RESPONSE TO SUBMISSIONS

Russell Vale Colliery Preliminary Works
Project Modification 4

Project Director: Barbara Crossley
Project Manager: Marion O'Neil
Report No. 3976/R02
Date: December 2018

FIGURE 5.1

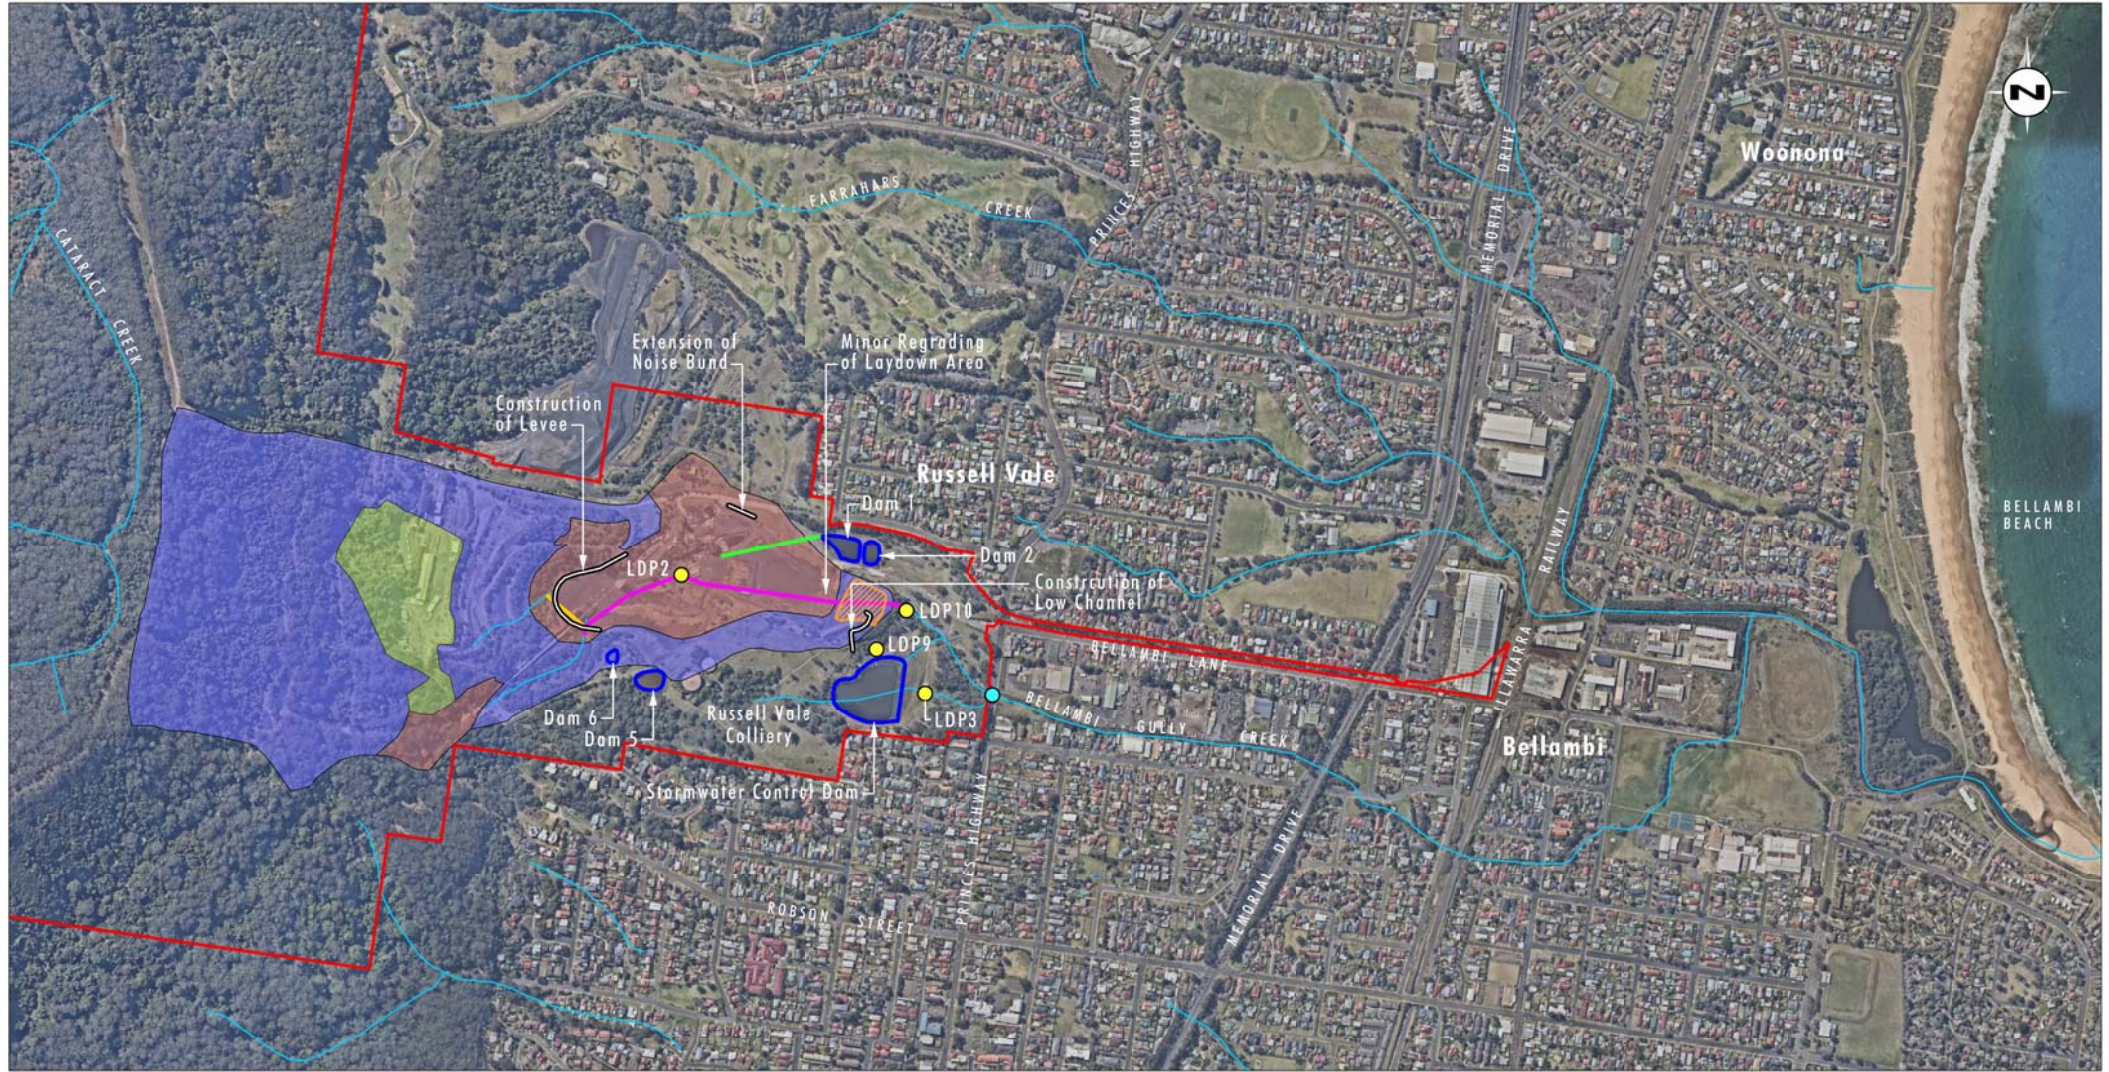
No assessment of potential environmental impacts of the proposed works was included in the Cover Letter, Bellambi Gully Flood Study or the Bellambi Creek Diversion Pipeline Assessment. Please provide an assessment of potential impact and proposed mitigation measures if Modification 4 were to be approved.

The current proposed location for the dry detention basin is the easternmost area of the laydown area with regrading of access routes to the west to redirect flows into the dry detention basin (see **Figure 5.1**). The current design includes an overflow channel to the SWCD. The volume of the basin in the laydown area is constrained by the depth to the Bellambi Gully Diversion Pipeline and the relocation of the noise bund (as part of the proposed UEP application). Initial investigations indicate that the maximum detention volume used during storm events is ~2.1 ML.

The updated stormwater management strategy proposed by Engeny (2018a) is a refinement of the Cardno (2015) design and is based on the outcomes of more detailed and up to date flood modelling. This strategy is illustrated on **Figure 5.1** and includes:

As described in **Sections 5.3 and 5.4**, the Engeny (2018a) modelling results indicated that the updated proposed flood management measures (**Figure 5.1**) will produce no adverse impacts off-site (refer to **Section 5.3** and **Table 5.2**).
